Construction Review of DSA321

This report is a summary of a series of meetings which took place between 1-2-91 and 1-9-91. All problems and concerns involving the construction of magnet DSA321 (the first 50mm short model) were discussed. They are listed in the approximate chronological order in which they arise during magnet assembly.

Figure 1.

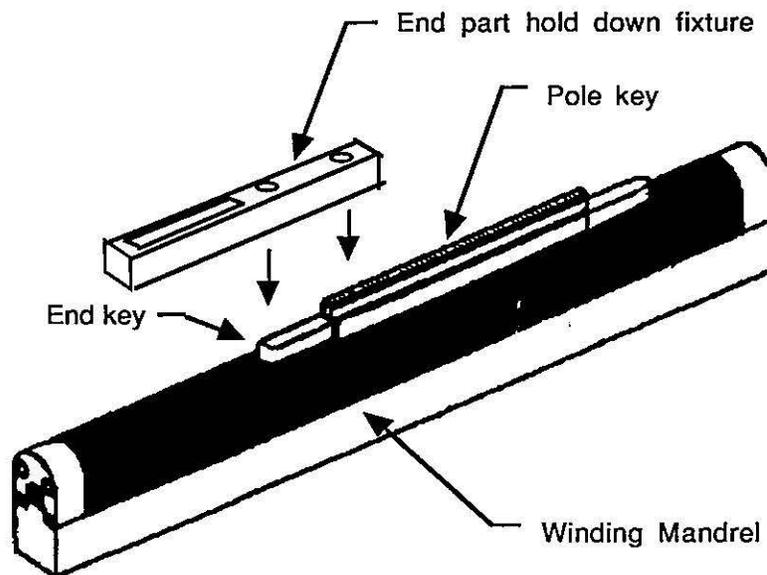
c.) During winding, a metal fixture is bolted to the pole keys on the winding mandrel as shown in Figure 1. It is used to hold the G-10 end parts down during winding. The fixture is so large that it interferes at times with the cable path. The operator must be careful not to nick the cable during the winding. Kerry Ewald will look into ways to reduce the size of the fixture without compromising it's function.

Figure 2.

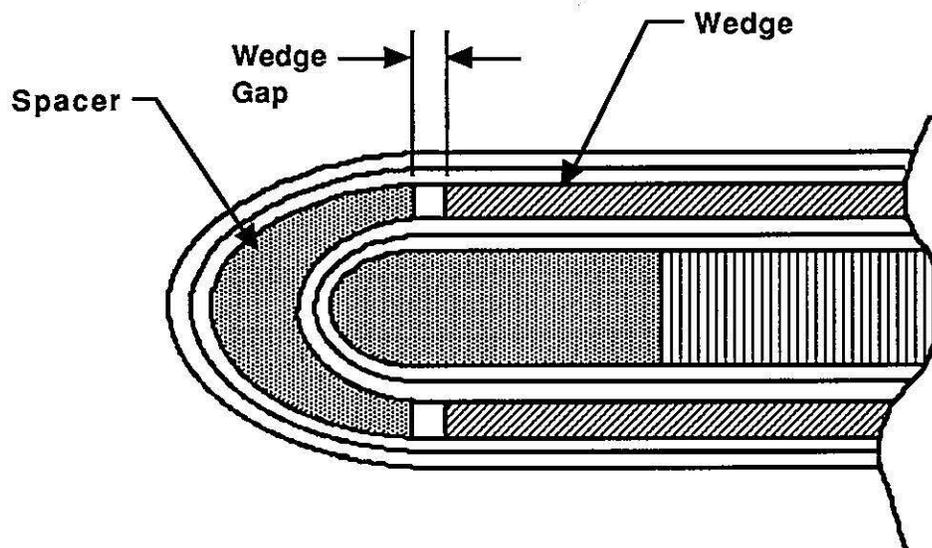
a.) Coil ends are each approximately 3/16 inch too long. This results in poor and inconsistent conductor support. It also causes longitudinal gaps between wedges and end parts (as shown in Figure 2) to be excessively large.

There are several possible causes for this problem. Cable paths on end parts could be allowing too little space. Poor end preloading could also be contributing. The parts, being thicker than their 40mm counterparts, are much stiffer. As a result they are much more difficult to push into position. Friction between the parts and the glass tape on the cable is very high, impeding end preloading.

The temporary solution for DSA321 was to live with the unmodified end parts and increase the wedge length by an appropriate amount to fill the gaps between wedges and end parts. The long term solution will involve four steps:

Figure 3.

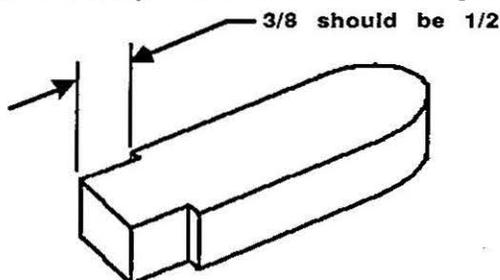
d.) Keys and end clamps are both relieved by a small amount to allow the kapton ground wrap to extend beyond the collar laminations longitudinally (into the area which is covered by the end keys and end clamps). A relieved key is shown in Figure 3. This is done to prevent the possibility of a ground short between collars and coil. The relief in the key is only $3/8$ inch while end clamp relief is $1/2$. The key needs to be changed to $1/2$ inch to conform to the end clamp. This will be done by Jeff Brandt.

Figure 4.

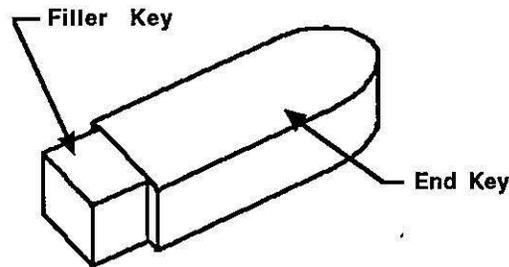
e.) The key relief referred to in 4d creates an inconvenient situation for the magnet assembly crew. The key must be placed into the coil before ground wrapping takes place. The technician assembling the ground wrap must therefore force the ground wrap into the small space provided between the key and coil pole turn. The solution may be to separate the relieved area of the key from the rest of the key as shown in figure 4. The relieved area would be a 1/2 inch long straight section of G-10 key and could be put in place after the ground wrap is completed. This and other solutions should be considered.

Figure 5.

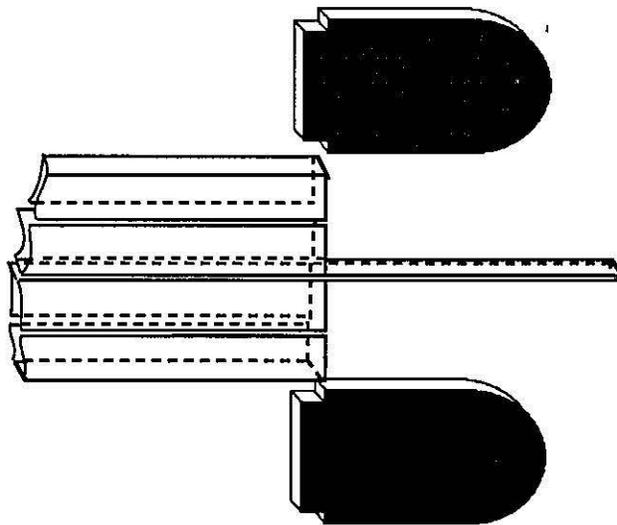
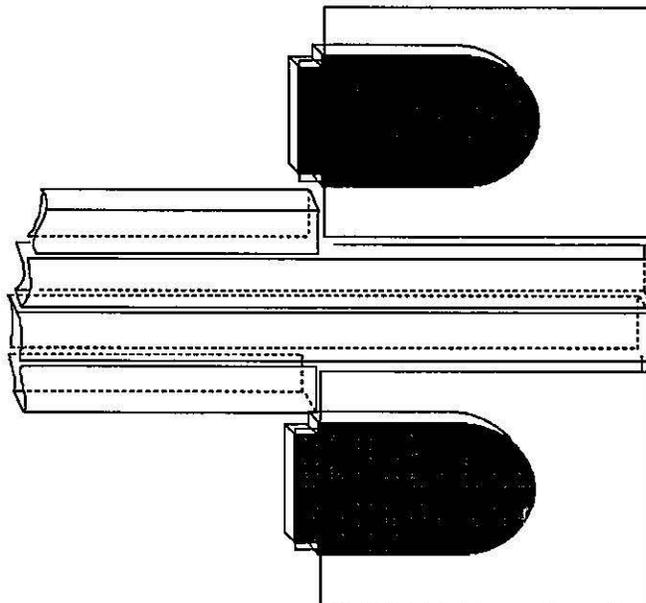
a.) All ground insulation was, by design, supposed to end 1/2 inch into the end clamp as shown on Figure 5. This does not allow for the outer coil caps to extend through the end clamp, causing an upper-to-lower coil short possibility to exist on the ends (although this same situation exists on the

Tevatron without any problems). The outer coil caps on DSA321 were extended all the way to the end of the coil as shown on Figure 6. The extra radial space at the poles was filled in by .005 kapton. This creates a .005 inch interference fit radially inside the end clamp area. This is not thought to be a problem because preload in this area is traditionally too low. Kapton also provides a slip plane for the coils and end parts against the end clamps.

This system will continue to be used on SSC short magnets until heater strips are incorporated. At that time the entire end ground wrap system will be changed.

Figure 7.

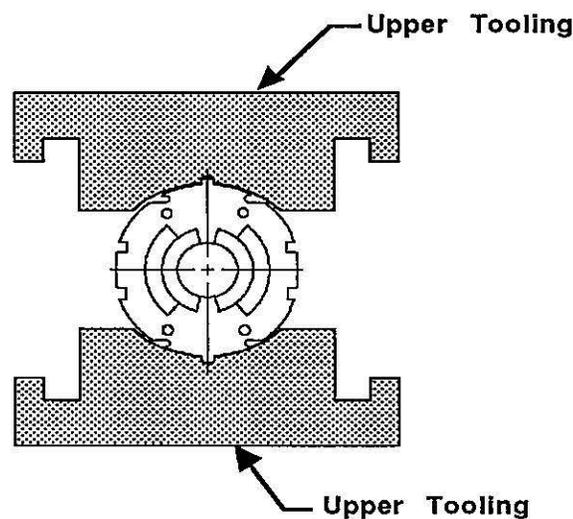
b.) The lower half of the collaring tooling was unavailable for DSA321. The upper half was split into two sections and used on both the top and bottom of the magnet as shown in Figure 7. The collaring tooling, after being split in two pieces, was only 36 inches long. As a result, the magnet had to be collared in two sections (incrementally).

The keys, instead of being pushed in by hydraulic cylinders, were placed in by hand. No problems resulted from the altered collaring procedure. Future magnets will be collared with the regular collaring tooling.

Figure 8.

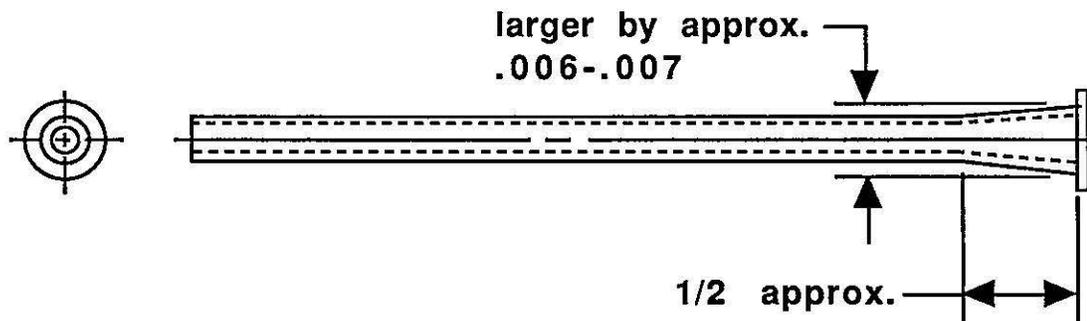
f.) Clearance between the collar pack pin and the hole in the collar lamination is very tight (.000 minimum thru .012 maximum by design). When the pins are manufactured the diameter near the flared end becomes slightly larger due to the flaring operation on the end as shown in Figure 8. This creates an interference fit between the pin and the collar for the last three or four spot welded pairs. The temporary solution has been to drill the holes in these pairs out slightly larger to fit the pins. A long term solution needs to be determined. Either the manufacturing process on the pin will need to be modified to prevent the pin from flaring or the collar lamination hole clearance will need to be increased.

Figure 9.

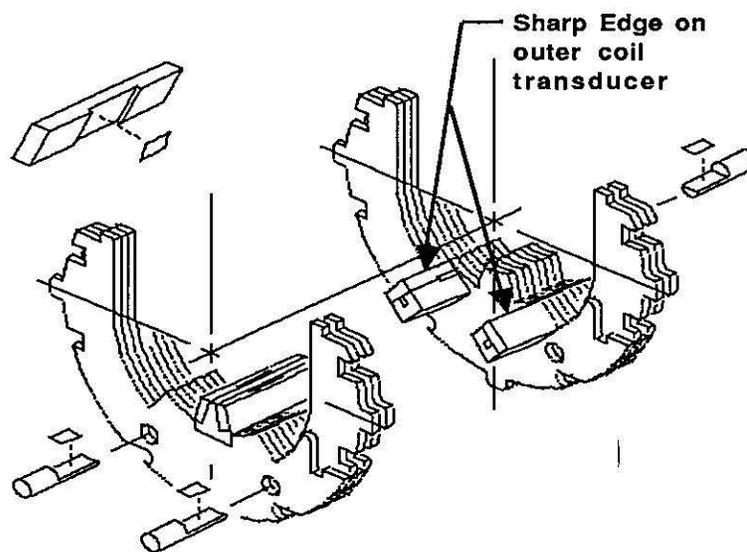
b.) When the collared coil was disassembled due to the turn-to-turn short, a serious amount of damage to the ground wrap was observed in the strain gage area. The sharp corner of the outer coil transducer block (as shown in Figure 9) had cut into the kapton ground wrap layers. Two of the three layers were completely severed. This problem did not exist on the 40mm magnets because the transducer block, due to the different geometry, did not directly contact the ground wrap. The solution on DSA321 was to round the corners on the transducer block before reassembling the magnet. This may or may not be an acceptable long term solution. Two steps need to be taken:

- Collar DSA322 with the rounded corner outer transducers. Dissassemble and inspect for damage.
- Calibrate some transducers both with and without the rounded corners to see if the calibration is affected by the rework.

Figure 10.

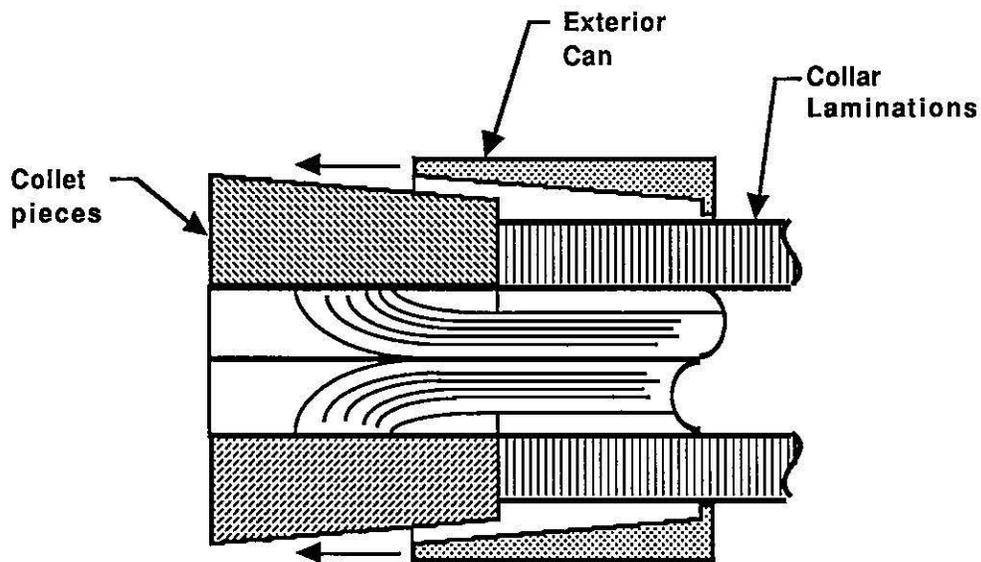
f.) The large exterior can of the end clamp must be driven onto the collet pieces from the inside "collared" area of the magnet toward the ends as shown in Figure 10. It is therefore necessary to slide this part onto the collared area of the coil before installation begins. When sliding the can onto the coil, there is a physical interference between the end clamp can and the inner-to-outer coil splice. The face plate of the end can must be slotted to allow the can to slide over the end without excessive bending of the splice

Figure 11.

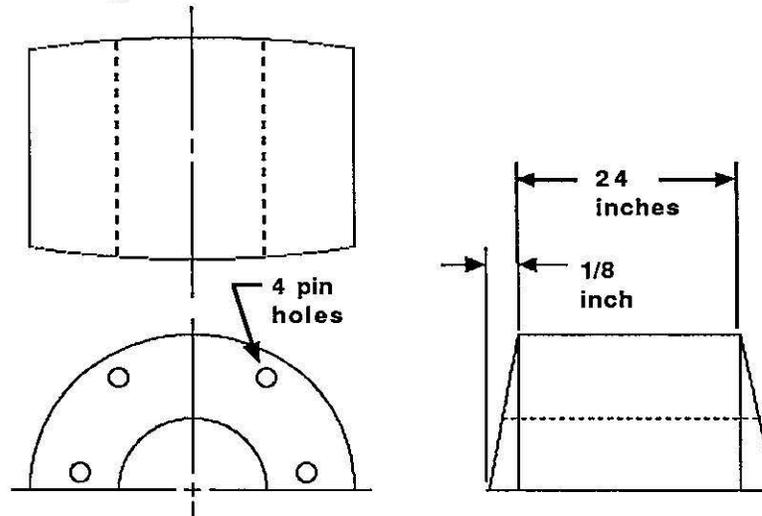
f.) The yoke packs, which presently have four pin holes, still do not retain a shape sufficiently parallel to meet the magnet requirements. Packs are "bellevilled" by as much as 1/8 inch on a 24 inch pack as shown in Figure 11. Several solutions are available. A fifth pin is possible. Welding of yoke packs is also being tried.

Figure 12.

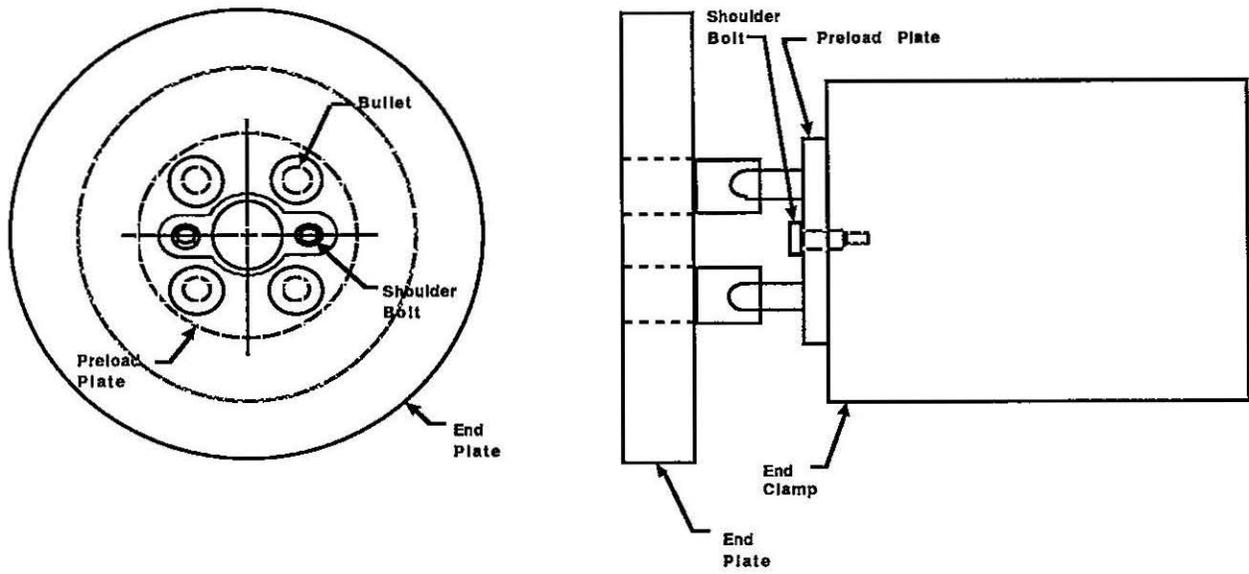
h.) The bullets are held onto the end clamp by means of a plate (called the preload plate) with two screws. The holes are by design placed on the vertical axis. On the 40mm magnets, the bullet/preload plate assembly was bolted firmly onto the end clamp. Alignment between the bullets and the end plate was done by adjusting the end plate at final assembly. This method will not work on the 50mm design because the end plates are welded to the skin and consequently not adjustable.

The 50mm solution is to drill oversize holes into the bullet preload plate. It is loosely attached to the end clamp by shoulder bolts through these holes before the endplate is installed. The bullet preload plate position is then adjusted to conform to the end plate after the end plate has been welded. The holes in the preload plate must be changed to the horizontal plane to allow access through the end plate. The assembly is shown in Figure 12.
